South Street, Exeter: Observations of Exeter Cycling Campaign

The Exeter Cycling Campaign welcomes additional provision for people to cycle or walk in the city. We have reviewed the [proposed contra-flow advisory cycle lane on South Street](#) and are grateful for the opportunity to comment on these.

Table 5-2: Cycle lane and track widths

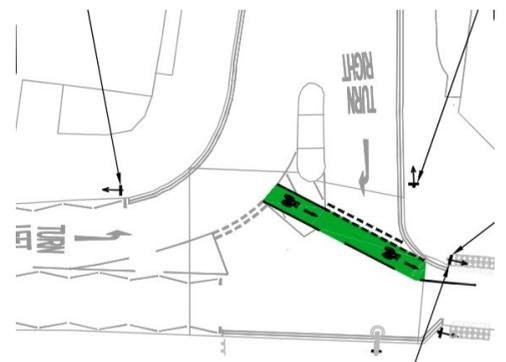
1. **Cycle path width:** It's proposed width (1m) appears to be narrower than "Absolute minimum" width laid out in the LTN 1/20 design standards.

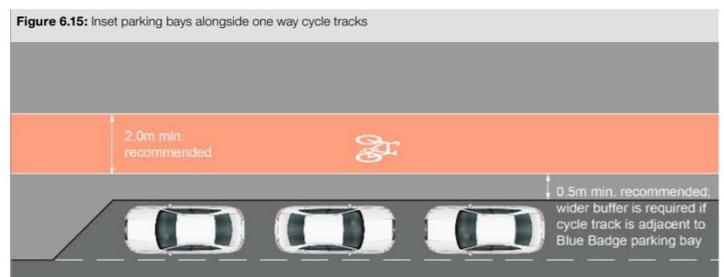
- Coombe Street Link:** Travelling in a northerly direction along South Street from Coombe Street people cycling are exposed to

multiple conflicting movements at the junction with Market Street in very quick succession, limiting their opportunity to observe and anticipate hazards. People cycling are offered no physical protection or separation approaching or half-way through the Market Street crossing and their route through the junction requires a difficult near-right-angle turn.

We recognise that changes to Coombe Street-to-Market street have been trailed as a future intervention. The link from Coombe Street to South Street is critical for joining up the quay to the city centre. This link is currently poor -with some green paint between Coombe Street and the pelican crossing but nothing thereafter.

Without improving this link we are concerned that any improvement along South Street will be of limited value.

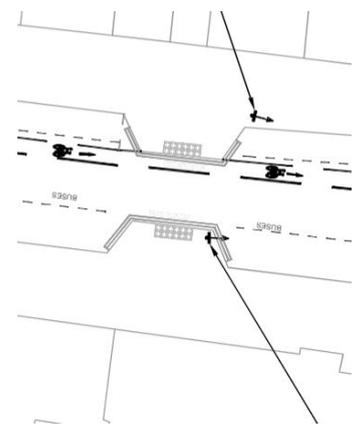
4. **Positioning of cycle path:** The proposal misses the opportunity to create a safe cycle path. This should be placed on the inside of the parked cars rather than outside. This would provide some protection from both the moving traffic along South Street and cars moving into and out of parking spaces. Moreover with the proposed design, coaches moving off from the East side of the road would risk swinging into the path of people cycling on the cycle lane, as they currently do on Paris Street (para 6.2.40 of LTN 1/20)
